**Work Order ID** 97722**\*97722\***

Item Name: Basket Hoop

DESIGN #	DRAWN BY	DART AEROSPACE LTD HAWKESBURY, ONTARIO, CANADA	
CHECKED #	APPROVED #	DRAWING NO.	REV. A
		D3166	SHEET 1 OF 1
DATE		TITLE	SCALE
02.07.10		BASKET HOOP	NTS
A	02.07.10	NEW ISSUE	
A1	04.04.08	38+/-1 w/s 36.0

DRAWING NO. D3166	TITLE BASKET HOOP	REVA1	<b>DART AEROSPACE LTD ENGINEERING ORDER</b>	D.E.O. NO. D3166-A-2	SHEET NO. 1 OF 1	SCALE NTS
DRAWN DATE	AJS 08.12.11	CHECKED 08.12.15	MFG. APPR. 08/12/15	APPROVED 08/12/16	DE APPR. 08.12.16

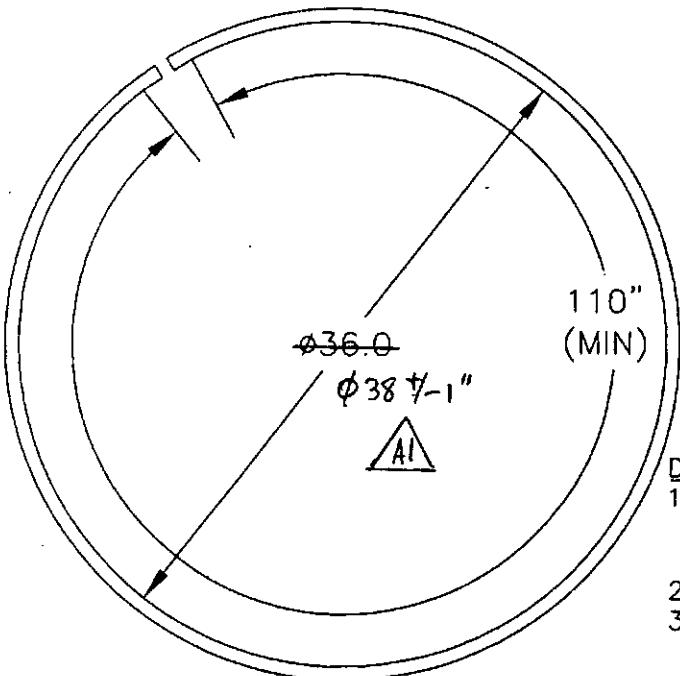
1) MODIFY MATERIAL NOTE FOR D3166-1 AS SHOWN:

WAS:

1) MATERIAL: AISI 304/316 SS SQUARE TUBING,  
0.75" x 0.75" x 0.063 WALL, 60.00" LONG  
(REF DART SPEC. M304TS0.750W.063)

2) MODIFY MATERIAL NOTE FOR D3166-3 AS SHOWN:

WAS:

1) MATERIAL: AISI 304/316 SS SQUARE TUBING,  
0.75" x 0.75" x 0.063 WALL, 120.00" LONG  
(REF DART SPEC. M304TS0.750W.063)

REASON: SEE PAR 08-005

IS:

1) MATERIAL: AISI 304/316 SS, 3/4 X 3/4 X 0.065 WALL SQUARE TUBING,  
60.00" LONG  
REF. DART SPEC M304TS0.750W.065

IS:

1) MATERIAL: AISI 304/316 SS, 3/4 X 3/4 X 0.065 WALL SQUARE TUBING,  
120.00" LONG  
REF. DART SPEC M304TS0.750W.065
